# K3 KIT ASSEMBLY MANUAL ERRATA

Rev. M-1, January 11, 2015

## MAKE THESE CHANGES TO YOUR MANUAL BEFORE STARTING INVENTORY AND ASSEMBLY

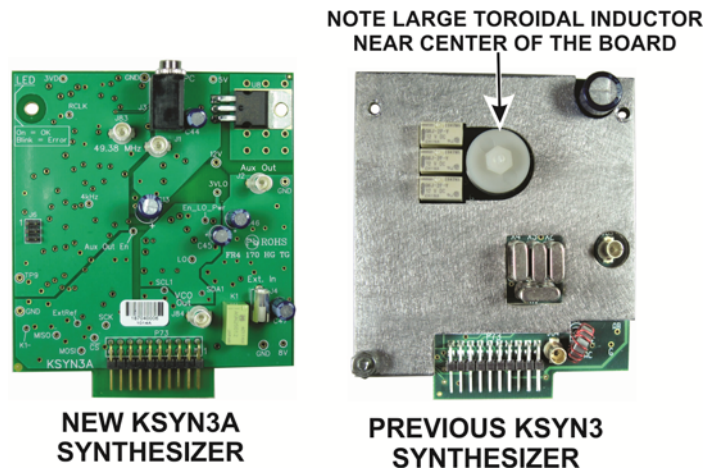
A new synthesizer pc board is now being shipped for your K3. The following changes are required to install the new board. The new and original synthesizer boards are shown below:

**Page A-5 (Parts List):** The “New KSYN3A Synthesizer” image above replaces the synthesizer shown. Change the part number of the synthesizer to E850638.
